PROJECT: Land to the north-west of Westhide, Herefordshire, HR1 3RQ (Ref: P214619/F)

CLIENT: Ersun (Westhide SPV) Ltd

Date: 24th October 2022

Landscape and Visual Impact Assessment Addendum: Amendments to Landscape Proposals

S:\PROJECTS\3350 - 3399\3352 - Westhild Solar\GRAPHIC\CAD\PILOT FILES

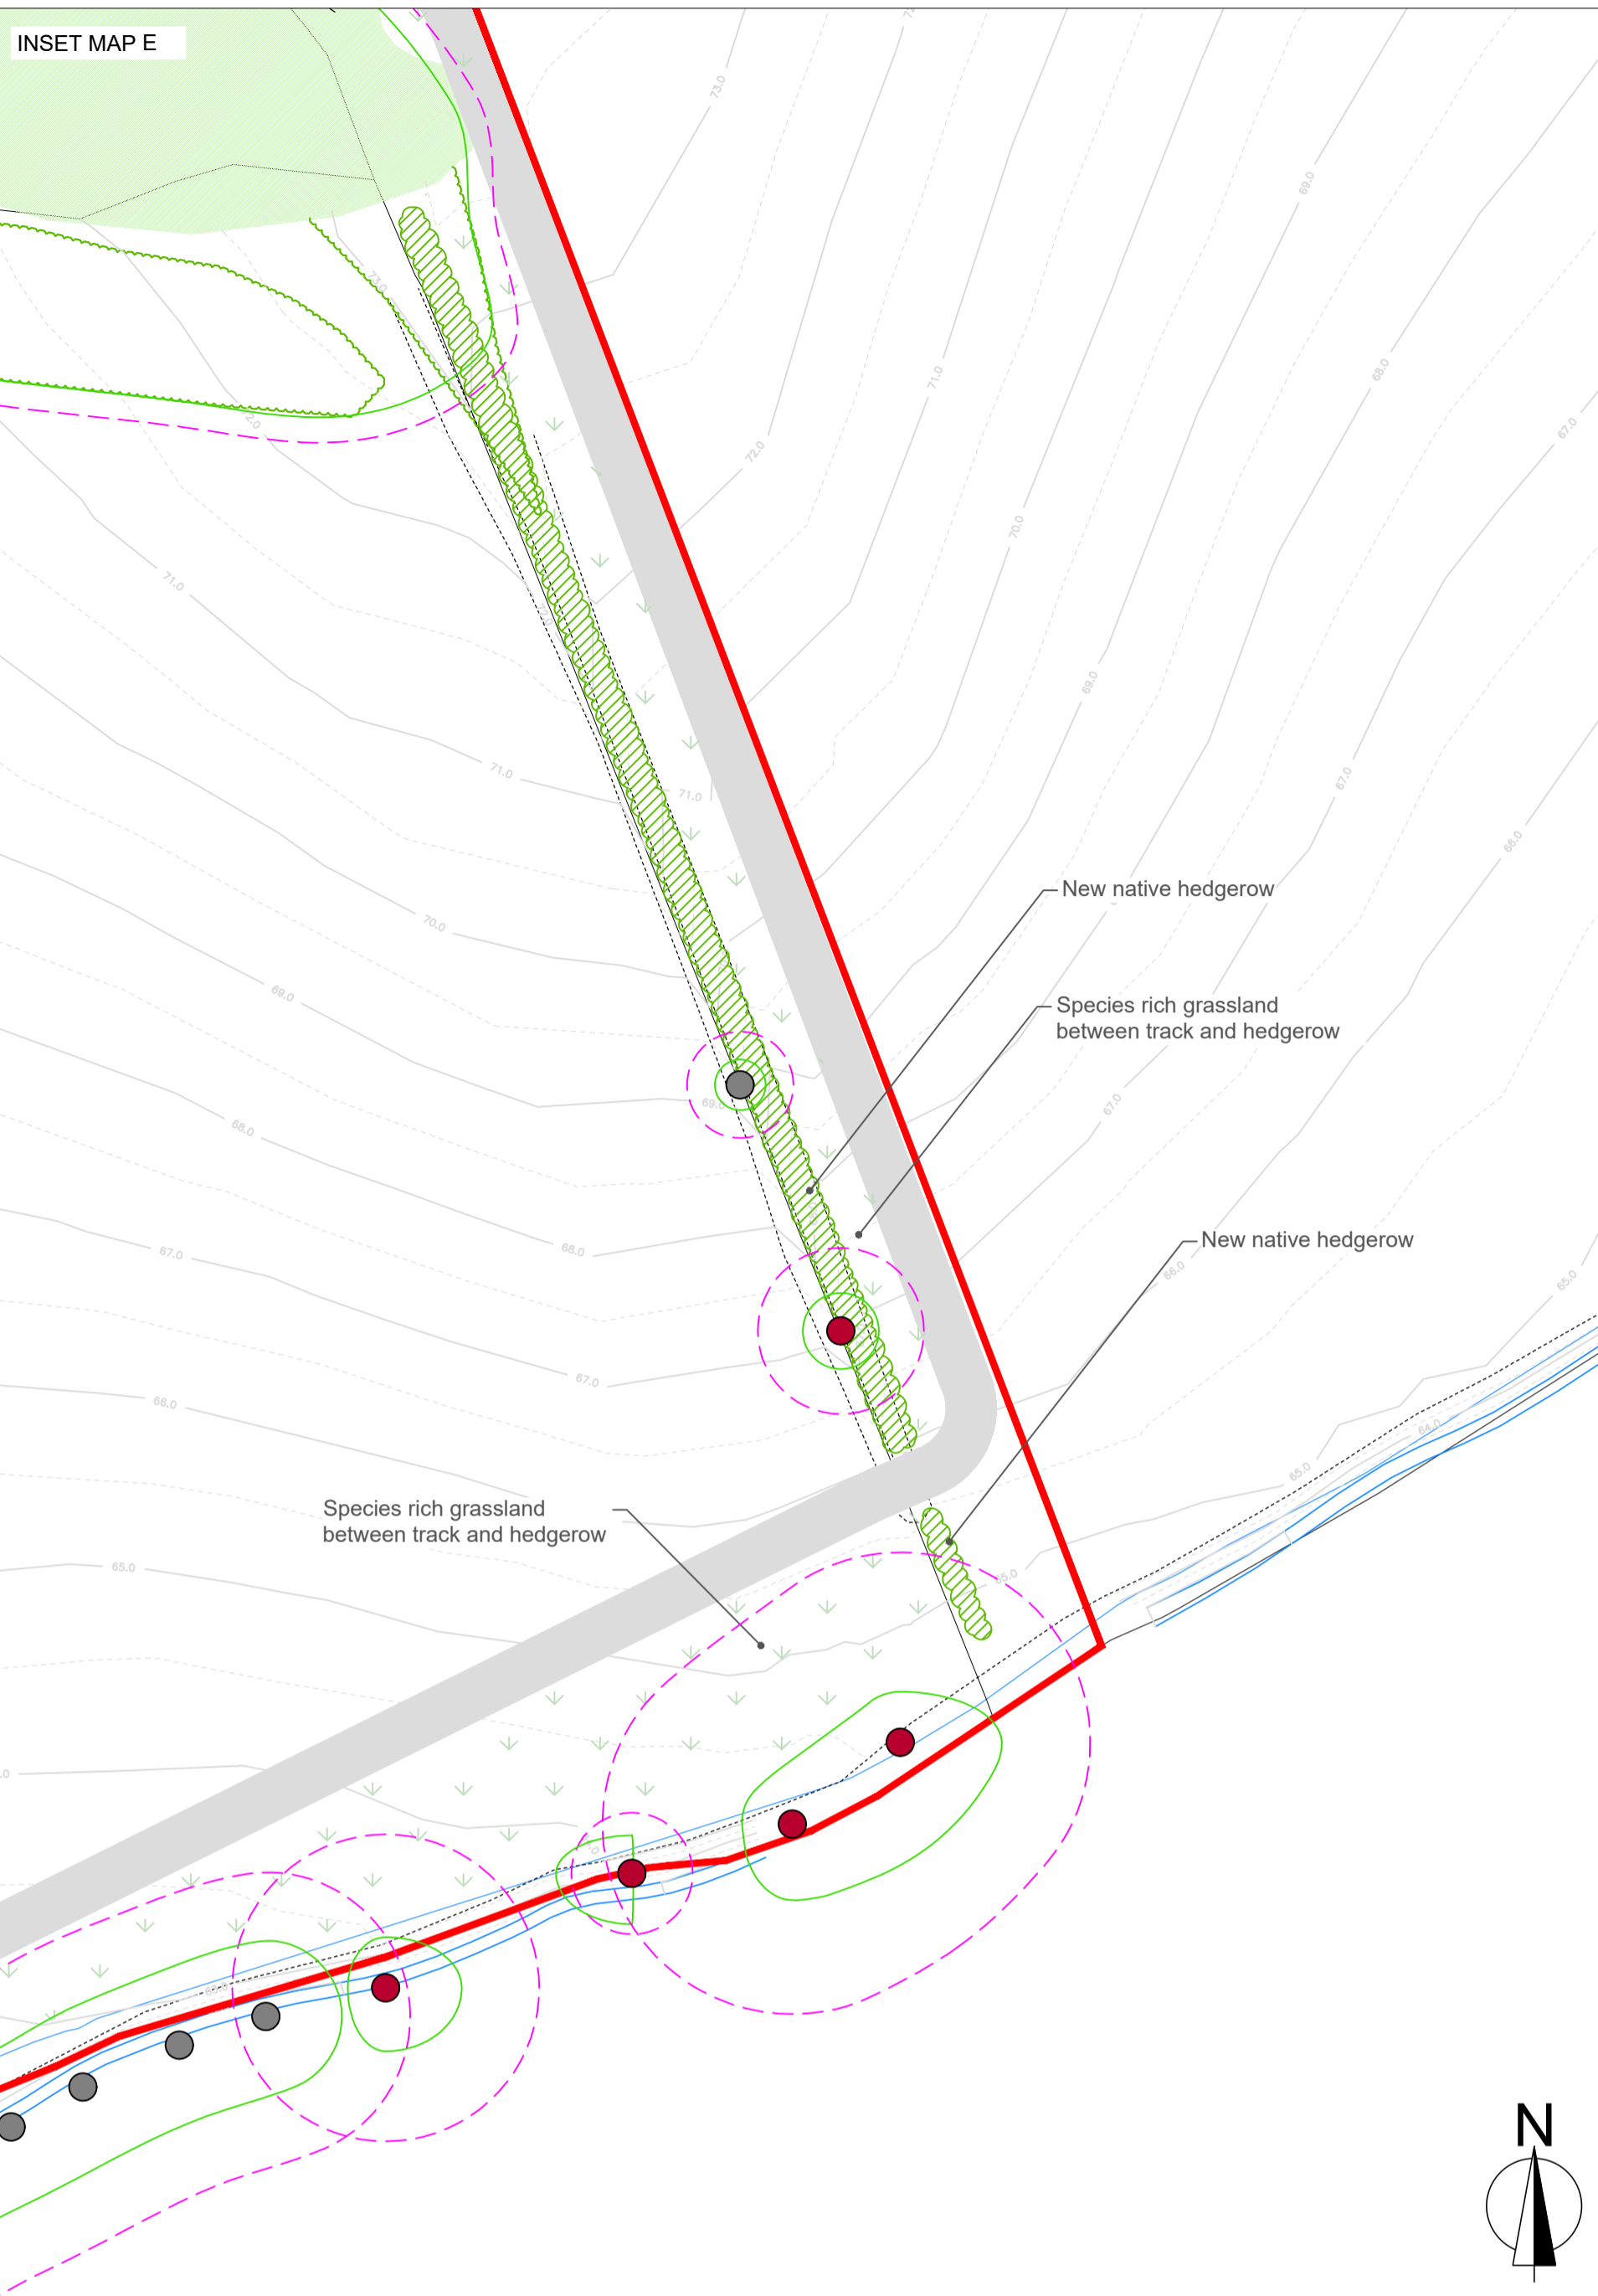
Fields A, D and E:

Proposed tree planting along the western boundary of Field A has been removed, as there is no longer a need to filter views of this field from the west. Tree planting to the eastern boundary of Field A and southern boundary of Field D has been retained to create a layering of vegetation, in combination with tree planting along the western and northern boundary of Field D. This is to assist in filtering views of the development in Fields C and F when views from the road to the south and from Westhide to the south-west.

Along the boundary between Fields D and E, the previously proposed hedgerow alongside the existing tree planting has been retained as part of the scheme to reinstate the historic field boundary and to enhance connectivity of natural features, including the isolated woodland block along this boundary. Similarly, the hedgerow has been retained along the eastern boundary of

Field E, restoring the historic field boundary and connecting the woodland belt with the vegetation along the stream to the south. Any additional tree planting along these boundaries have been removed as there is no longer a need to filter views of the development in Field E from viewpoints to the west.

Fields H and I:

The previously proposed tree planting along the eastern and western boundaries of Field I have been retained. The density of tree planting has been reduced slightly as additional tree planting is proposed along the eastern boundary of Field G which will contribute to the layering of vegetation, filtering views of the development in Field G when viewed from the road and properties to the east. Proposed hedgerow across Field H has been removed to retain a larger Field, which will be beneficial to ongoing agricultural uses.

CLIENT ERSUN (WESTHIDE SPV) LTD		
PROJECT WESTHIDE SOLAR		
TITLE LANDSCAPE MITIGATION AND ENHANCEMENT PLAN - INSET 3 OF 4		
Status: PLANNING	Drawn: JH	Checked: LF
Scale: 1:2,000@A1	Date: 03.12.2021	Approved: AS
Drawing Number: 3352_L_GA_1_03		Rev: B

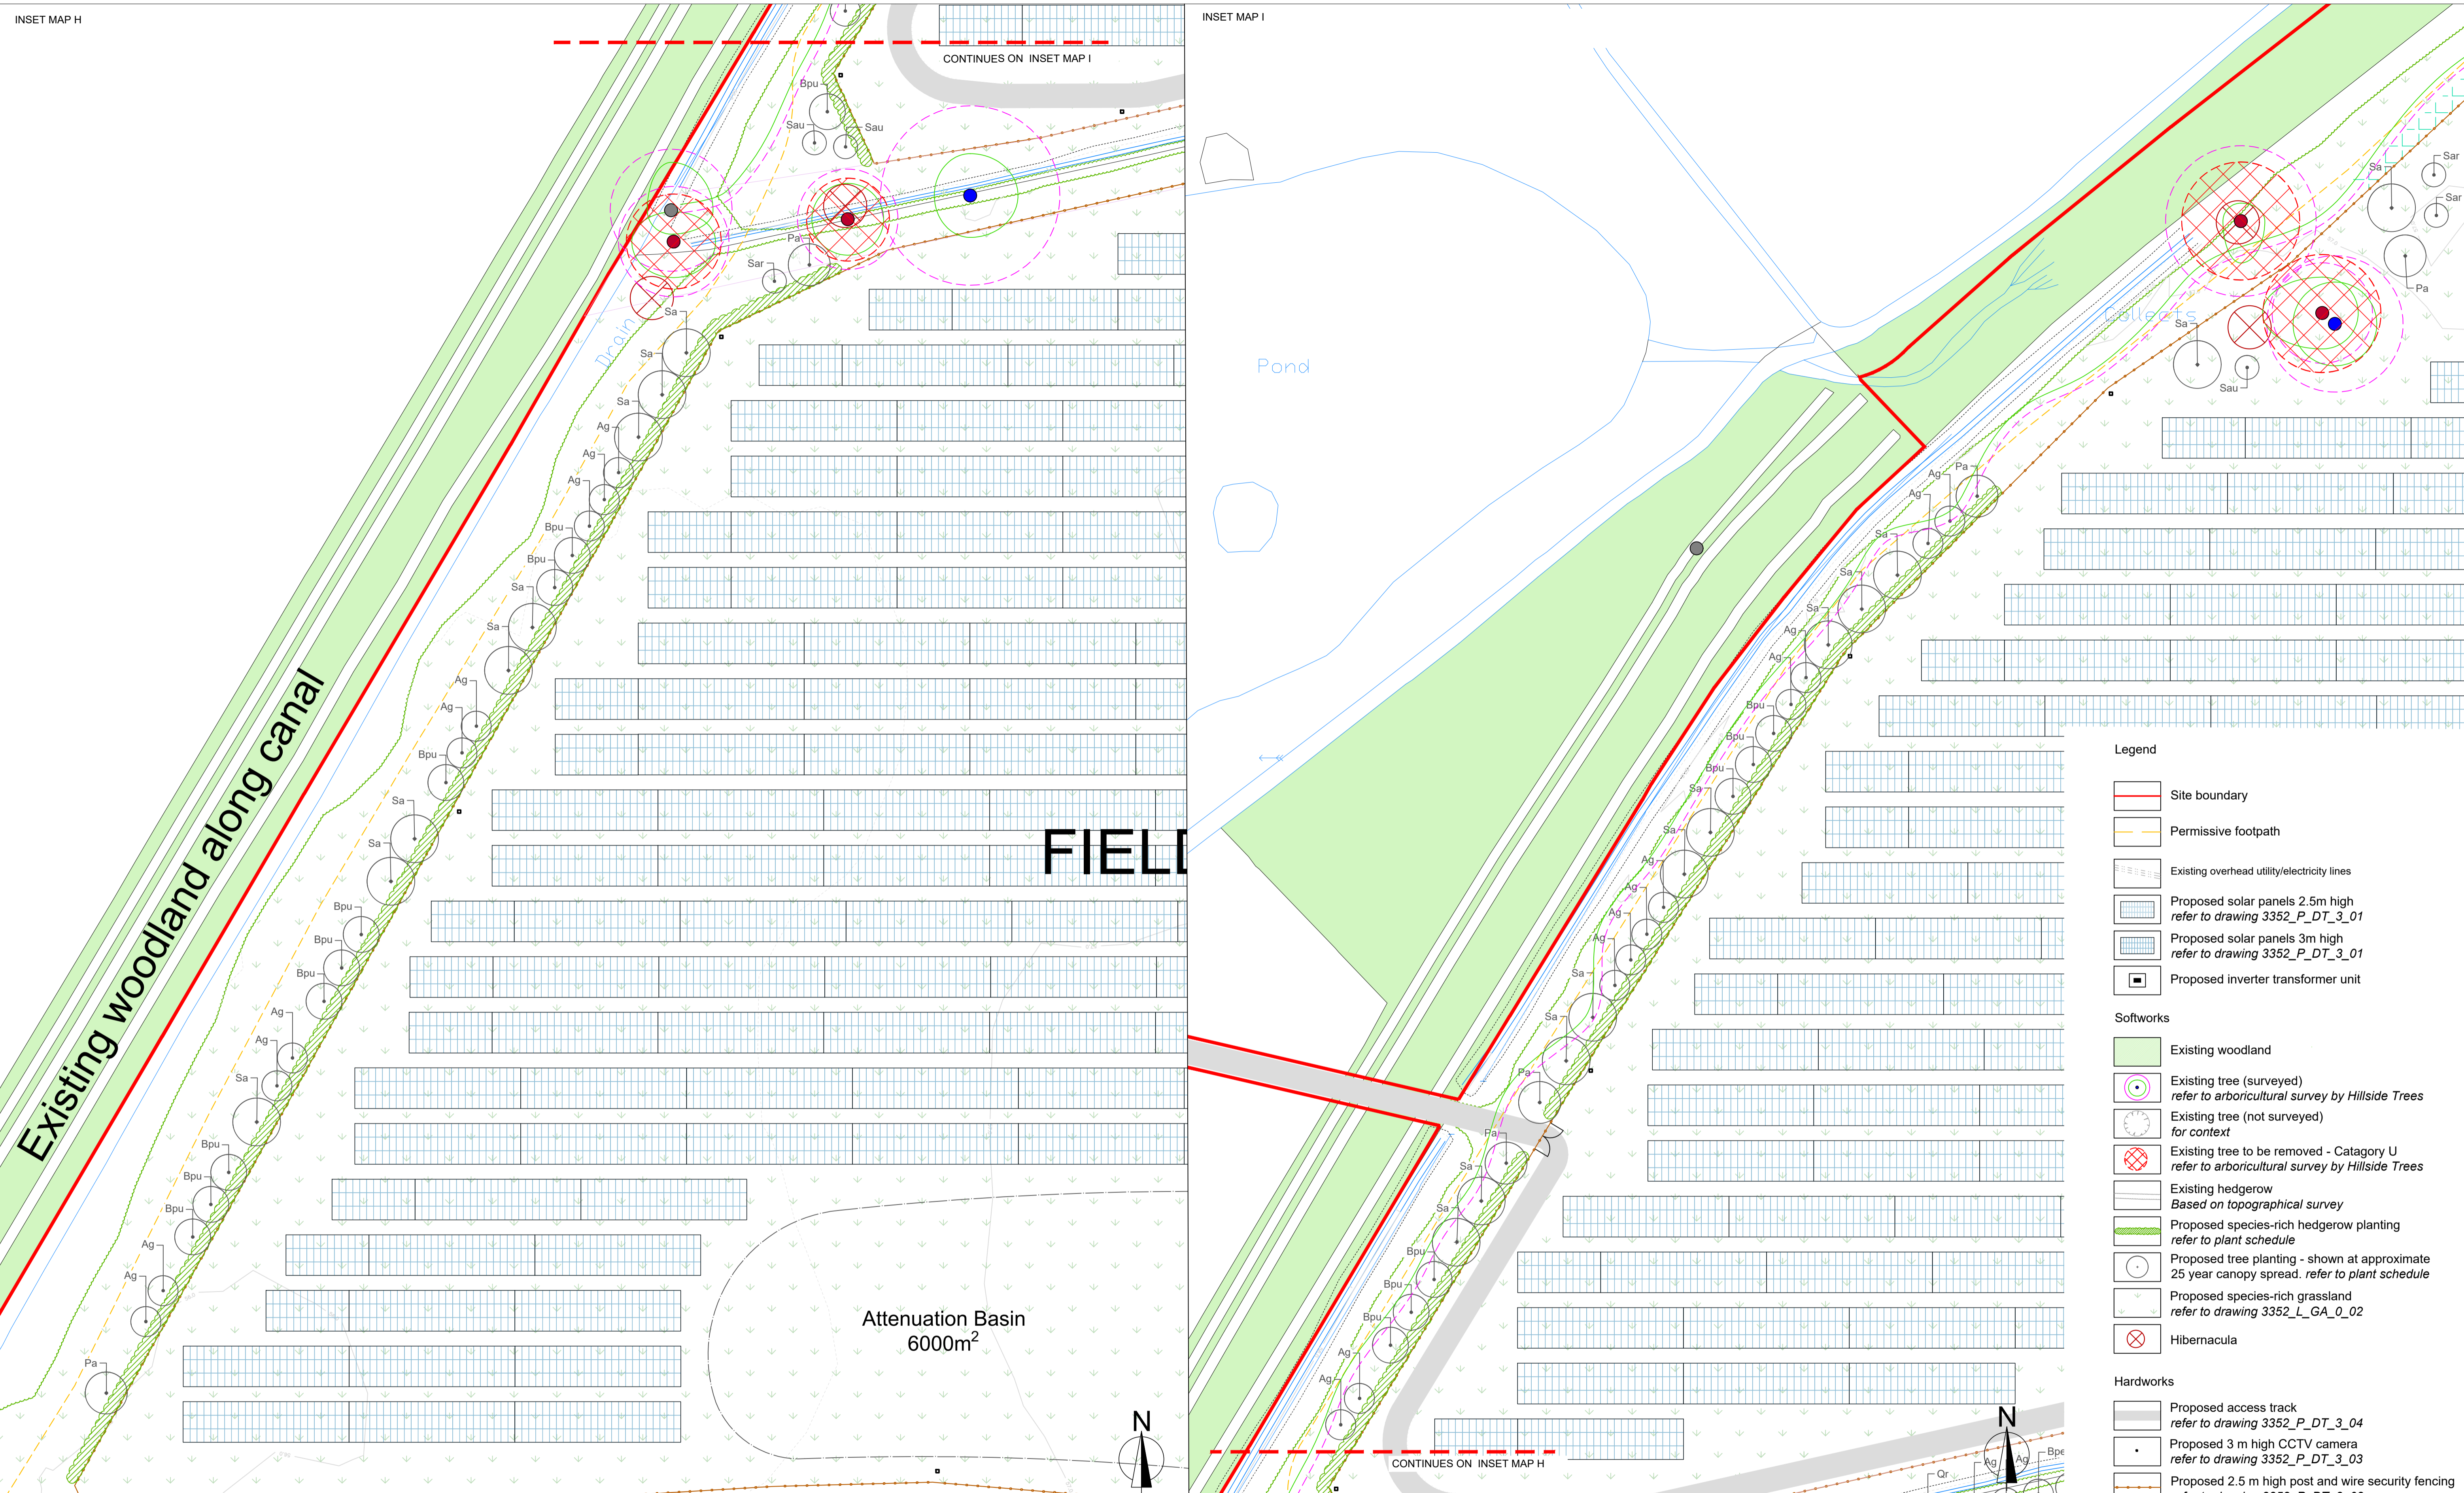
Rev:	Date:	Description:	Drawn	Ch'd
A	17/06/2022	Updated proposals to respond to comments from the local authority	JH	AS
B	20/10/2022	Panels removed from Fields A, D, E, H and I. Mitigation planting revised to suit.	JH	AS
